ADDENDUM #2 – MARCH 3, 2025

RE: CITY OF PORT ORFORD
Community Building Remodel
Project #18.27.2

FROM: HGE ARCHITECTS, Inc.
333 South 4th Street
Coos Bay, Oregon 97420
541-269-1166

SHEET TITLE:
HVAC FLOOR PLAN

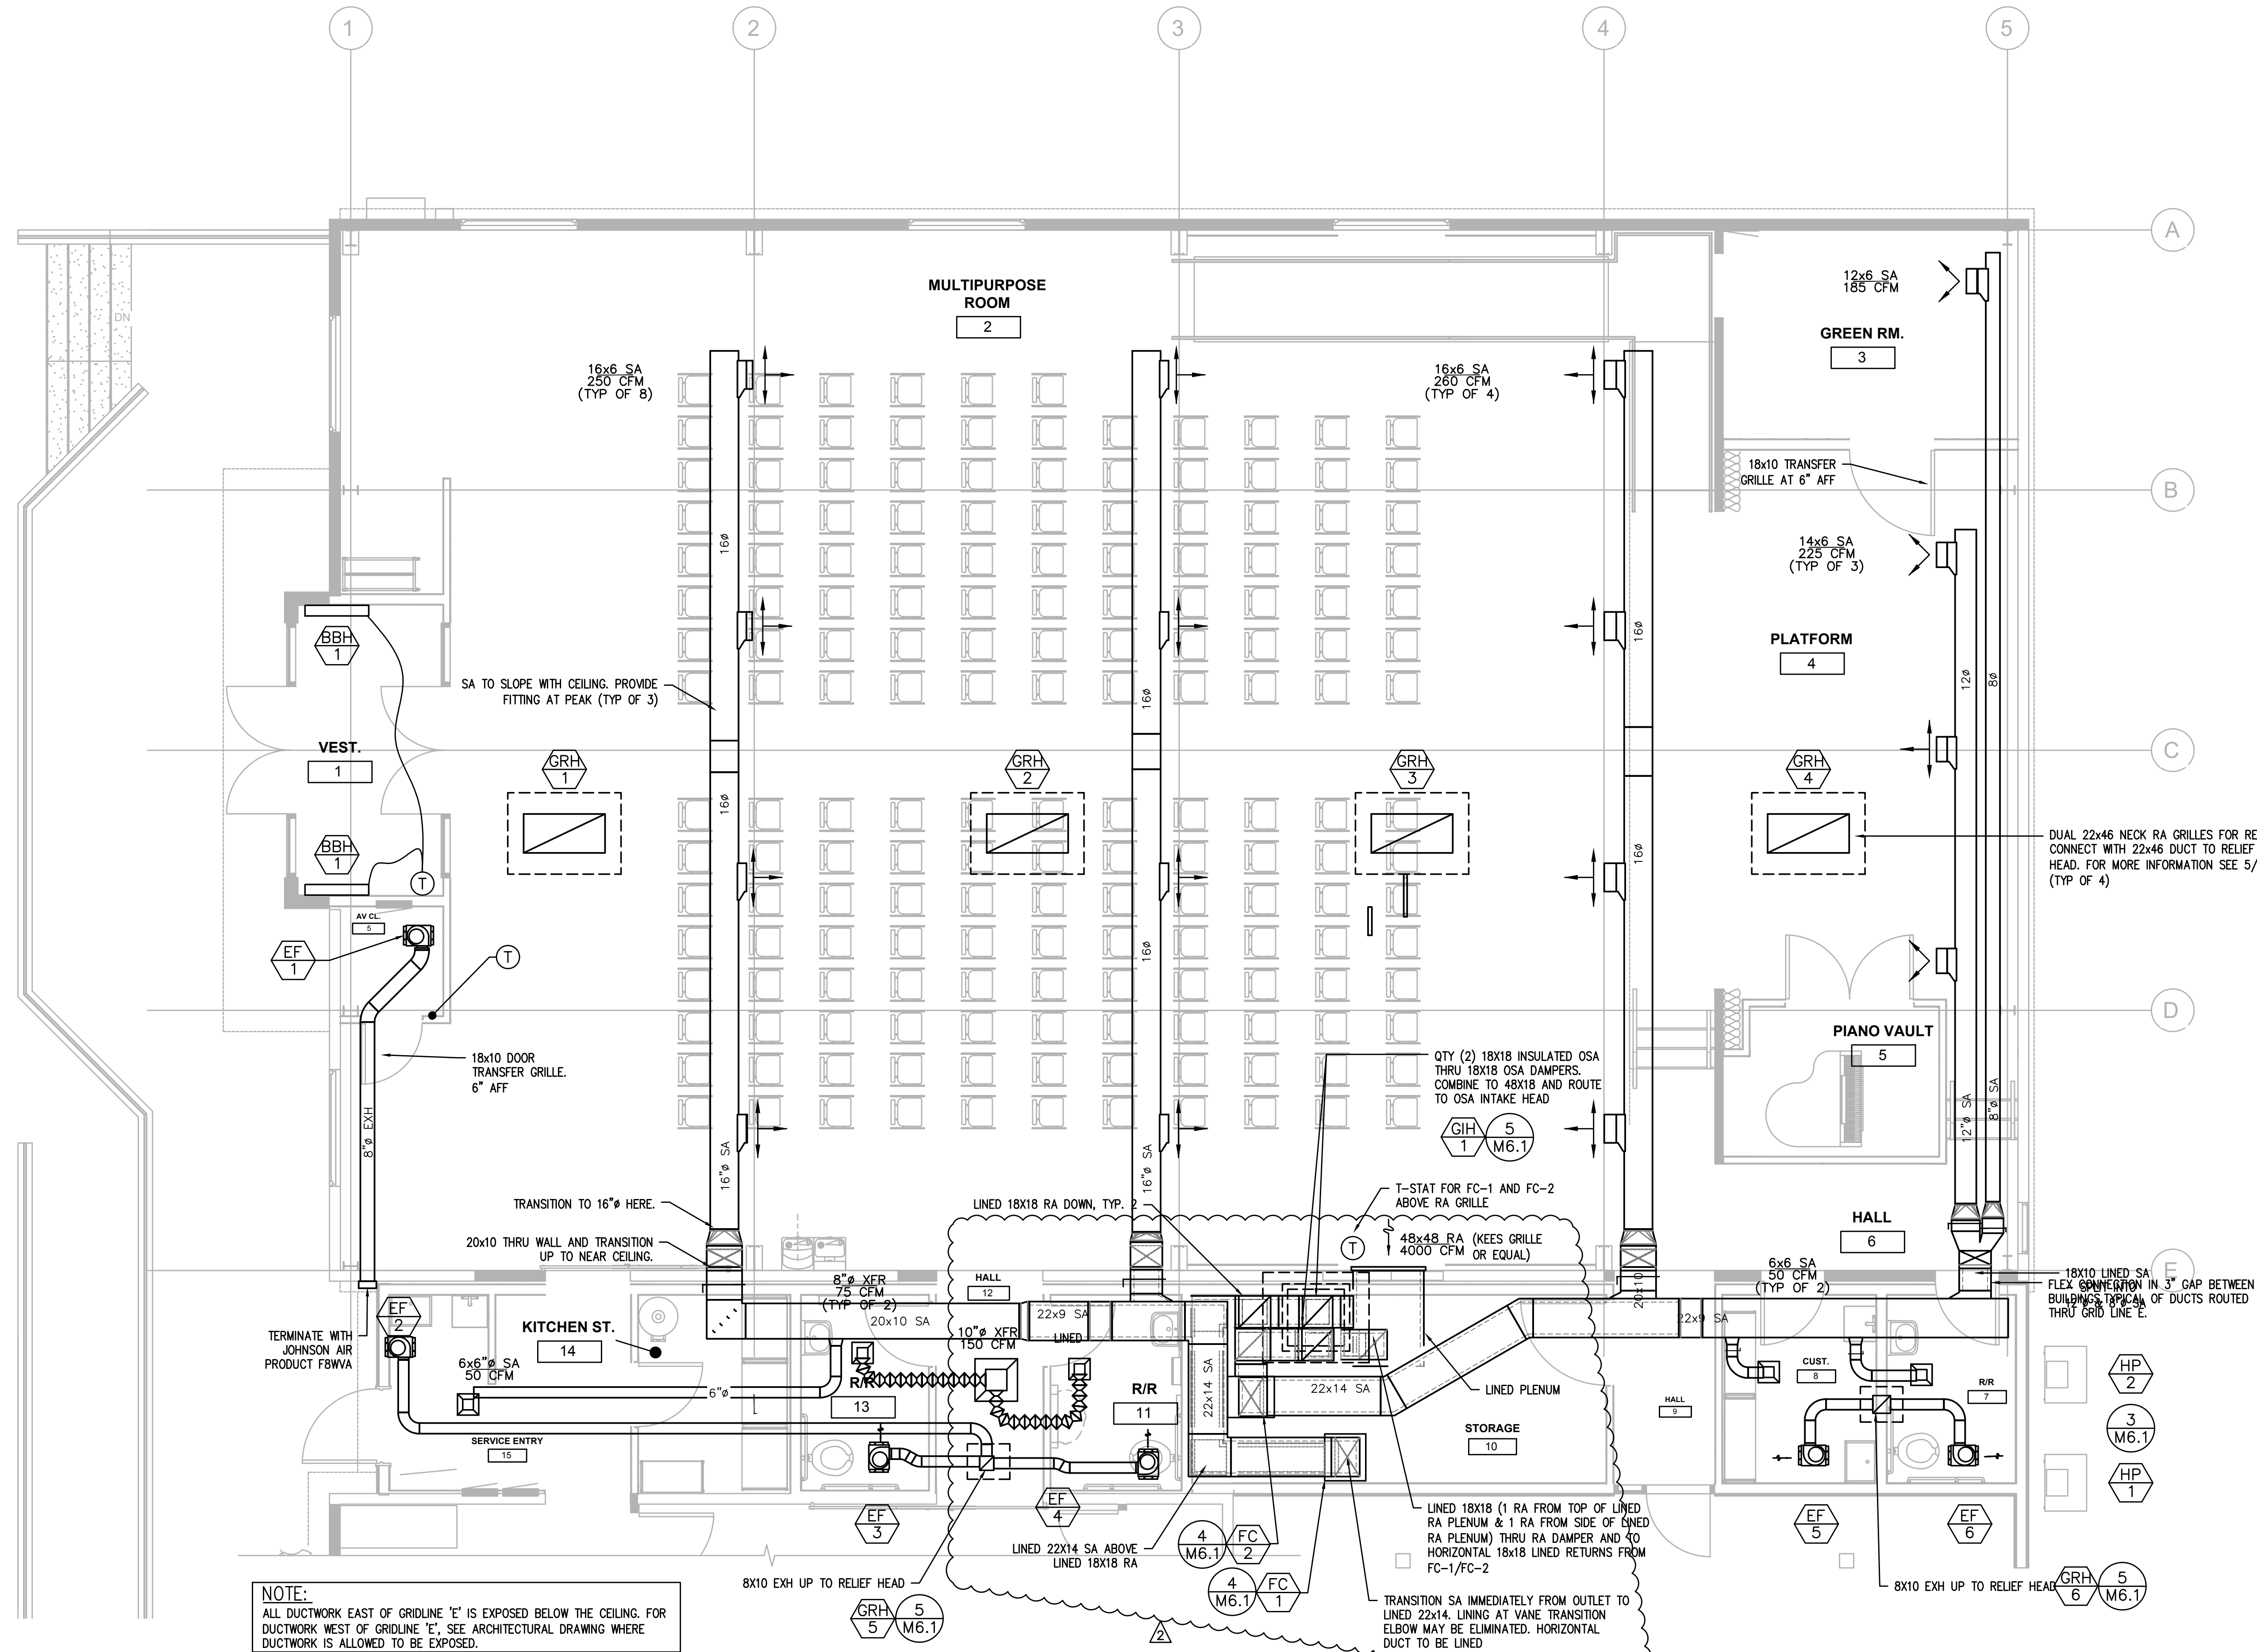
7. **Sheet M2.1 HVAC Floor Plan:** REPLACE with the attached revised sheet in its entirety. Revisions include:
 - a. Revised sizing of Supply Air Main off FC/1.

- b. Added a transition to 22x9 SA after main take-off to serve Multi-Purpose.
 - c. Added note for lining on RA plenum for 48x48 Low RA Grille.
8. **Sheet M6.0 Mechanical Schedules, Exhaust Fans Schedule:**

SHEET TITLE:
**ELECTRICAL PLANS
POWER & SIGNAL**

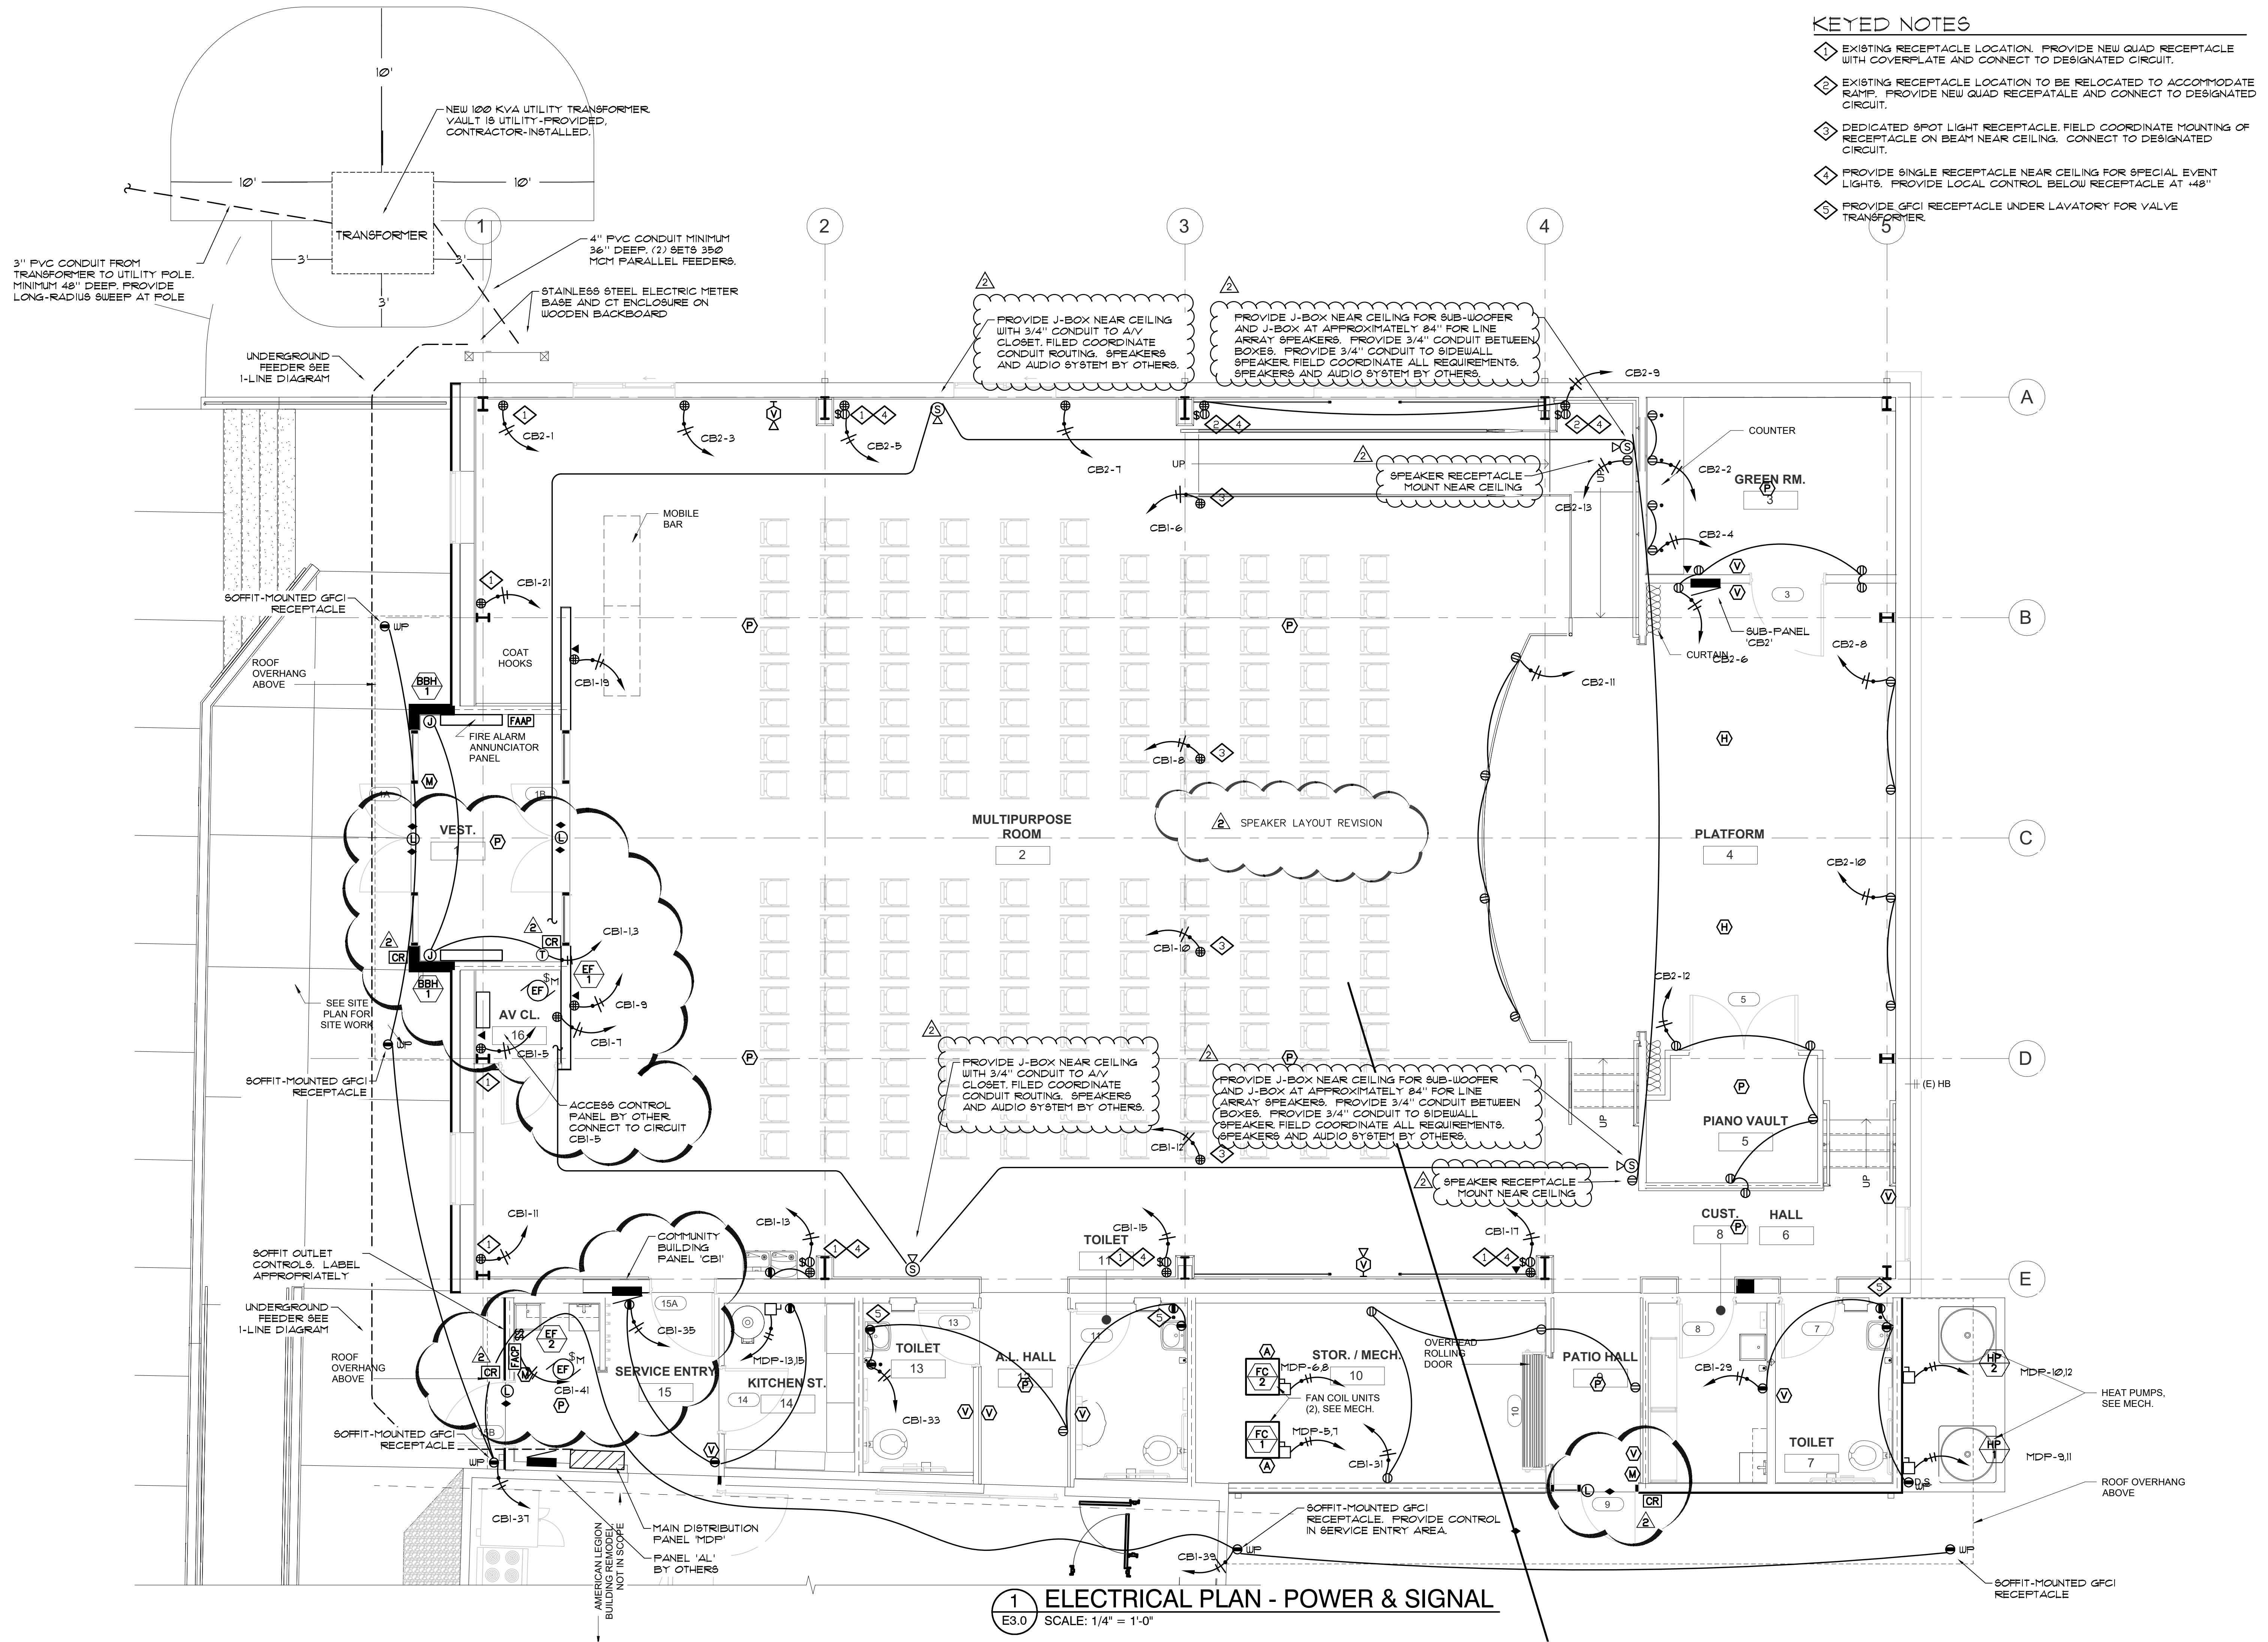
11. Sheet E3.0 Electrical Plans Power & Signal: REPLACE with the attached revised sheet in its entirety. Revisions include:

- a. Access control at Door #s 1A, 1B, 9, and 15B per Addendum #1. Access control panel added in AV Closet.
- b. Revised speaker layout and added electrical rough-in at revised locations.
- c. Added speaker receptacles for future use.
- d. Relocated Panel CB1 next to Door #15A.
- e. Relocated Fire Alarm Control Panel next to Door #15B.
